Well Name: JAMES RANCH UNIT DI 11 EKALAKA

Notice of Intent

Procedure Description: **Name Change, Spacing, Casing/Cement, Drilling Variance Changes XTO Permian Operating, LLC requests permission to make the following changes to the original APD: No Additional Surface Disturbance Change Well Name fr/James Ranch Unit DI 11 Ekalaka 802H to James Ranch Unit DI 11 Ekalaka 922H Change BHL fr/2310'FSL & 50'FEL, Section 15-22S-30E to 1980'FNL & 50'FEL, Section 15-T22S-R30E Casing/Cement design per the attached drilling program. Attachments: C102 Drilling Program Directional Plan Multibowl Diagram

Well Plan Report - JRU DI11 Ekalaka 922H

CACTUS WELLHEAD LLC 20" x 9-5/8" x 7-5/8" x 5-1/2" MBU-T-CFL-R-DBLO Wellhead With 11" 10M x 7-1/16" 15M CTH-DBLHPS Tubing Head And 9-5/8", 7-5/8" & 5-1/2" Pin Bottom Mandrel Casing Hangers	XTO ENERGY INC ICARUS PAD		
	DRAWN	DLE	18JAN21
	APPRV		
	DRAWING NO. HBE0000479

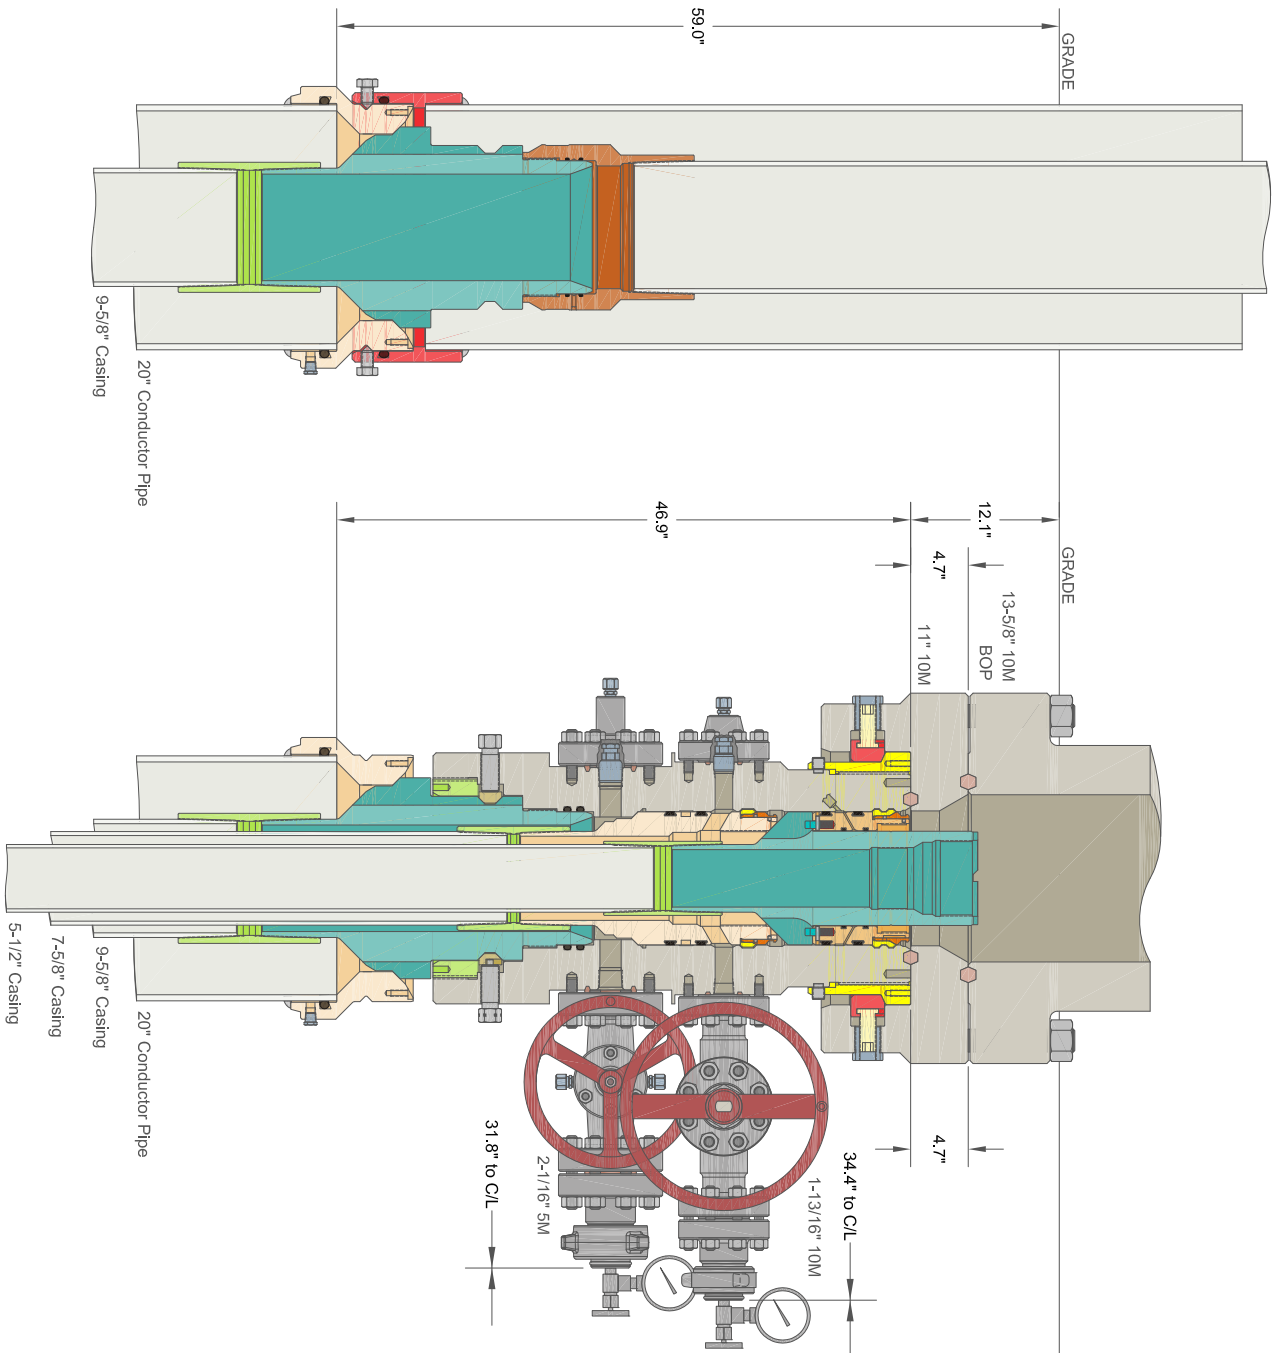
- A. Starting Head: 13-5/8" 10M top flange x 13-3/8" SOW bottom
- B. Tubing Head: 13-5/8" 10M bottom flange x 7-1/16" 15M top flange
 - Wellhead will be installed by manufacturer's representatives.
 - Manufacturer will monitor welding process to ensure appropriate temperature of seal.
 - Operator will test the 7-5/8" casing per BLM Onshore Order 2
 - Wellhead Manufacturer representative will not be present for BOP test plug installation
